# Access Compliance Report

## Public Rights-of-Way

| Intersection ID: 2573 | Main Street: CAMBELLTON_DR | Cross Street: PELORUS_LN | Location: SW           |
| ADA ID: E2A8ACD2EAAA  | Ramp Type: PerpDiag        | Initial Pass/Fail: Fail  | Overall Compliance: No |

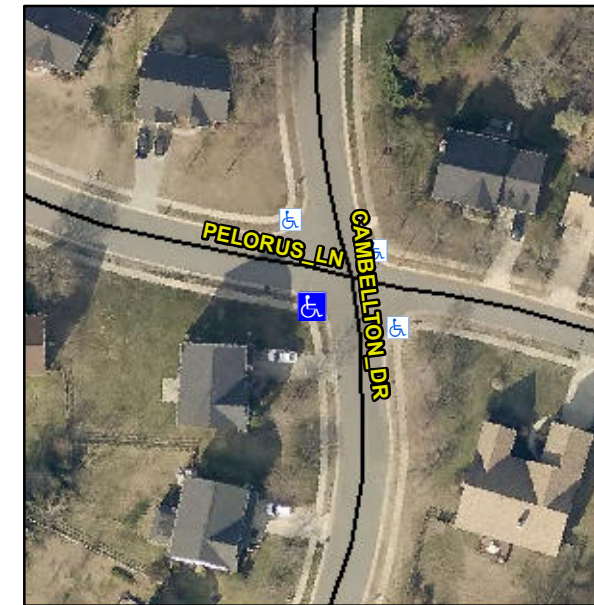
**R304.2.2, R304.5.3**

| Compliance | Description           | Data | Compliance | Description                 | Data |
|------------|-----------------------|------|------------|-----------------------------|------|
| N/A        | Ramp Length (in)      | 45.5 | No         | Ramp Slope (%)              | 14.7 |
| Yes        | Ramp Width (in)       | 64.0 | No         | Ramp XSlope (%)             | 3.6  |

**Remove & Replace Curb Ramp With Two New Directional Ramps or Equivalent.**
